**BFN Relicensing ER Information Needs – March 2004**  
**Socioeconomics & EJ**

**BFN Relicensing ER Information Needs – March 2004**  
**Socioeconomics & EJ**

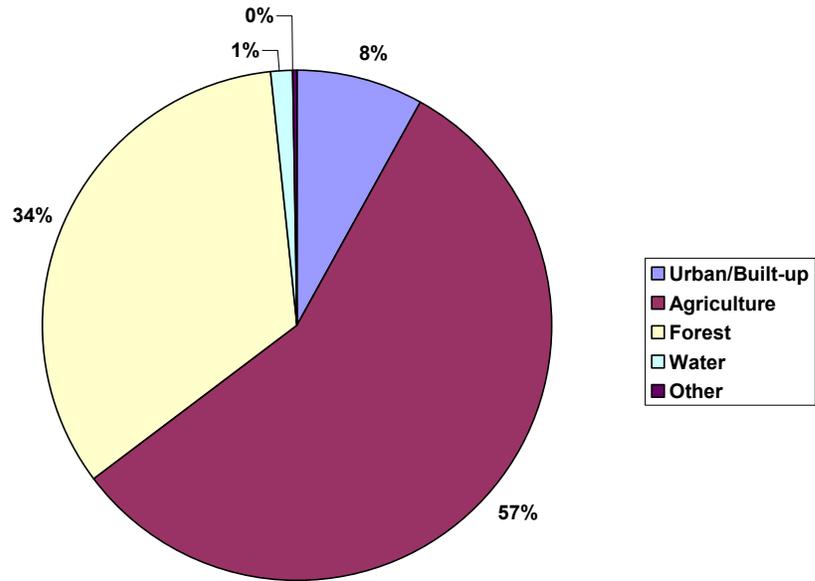
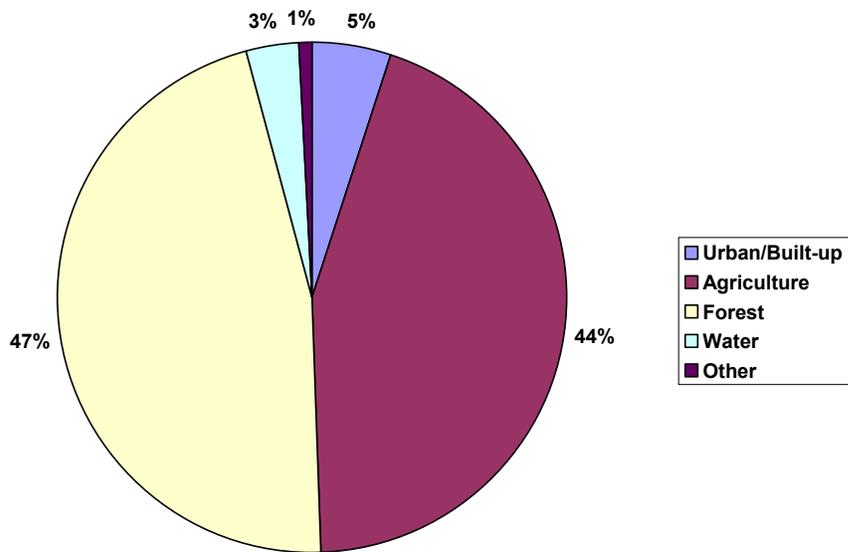
4. Page E-54 of the ER provides a pie chart illustrating the land-use break out of Limestone County. Is this information also available for Madison and Morgan Counties?

Response: Yes. Pie charts for all three counties are shown below.

**Browns Ferry Nuclear Plant  
Impact on TVA's Distribution Allocation  
to the State of Alabama**

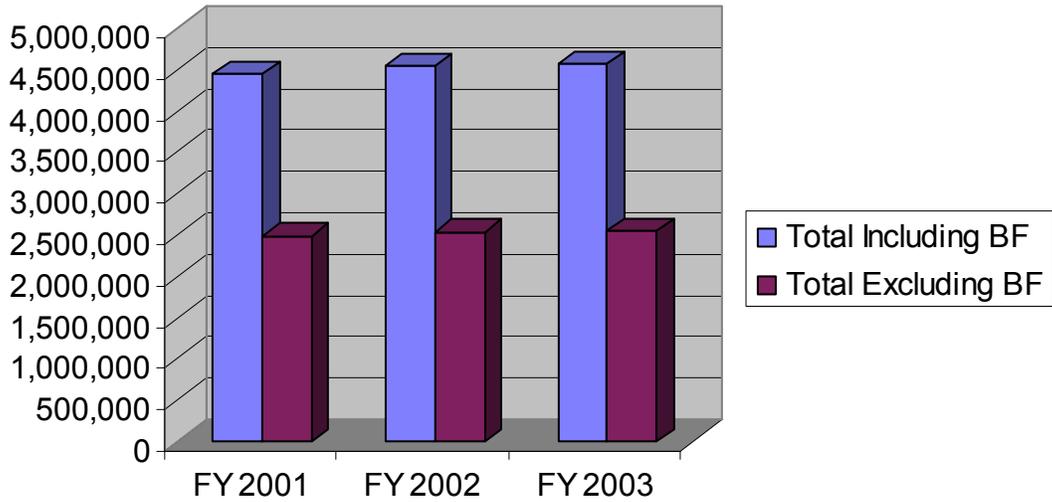
6. It would be helpful to have the total amount of taxes paid by TVA on the assessed value (if appropriate) of the Browns Ferry nuclear plant for the past five years, specifying the type of tax (e.g., property tax) and the entity to whom it is paid (it was not clear from the ER what the total amount of taxes paid by TVA was, the type of tax, and to whom it was being paid...is there any amount of tax that is paid directly to a local county or school district entity or is all to the state?). If it is all paid directly to the state and then redistributed to counties, please explain the criteria for distribution and indicate the amount the final recipient receives (for the corresponding years). In order to determine the impact of BFN under various scenarios, it will also be necessary to compare the amount that is paid by TVA with the total amount of revenues collected by the taxing entity (e.g., Limestone County or school district).

Response: TVA makes in lieu of tax payments to each state in which it sells electric power or has power property. Each state determines if and how allocations are made to local governments. A detailed explanation is given below. This explanation is followed by graphs and tables showing our latest estimates of impacts on the state and on Limestone, Madison, and Morgan Counties. Total revenues and receipts of Limestone County were \$20,082,621 in Fiscal Year 2002-2003\*<sup>1</sup>. The TVA payments constituted almost 23 percent of this amount.
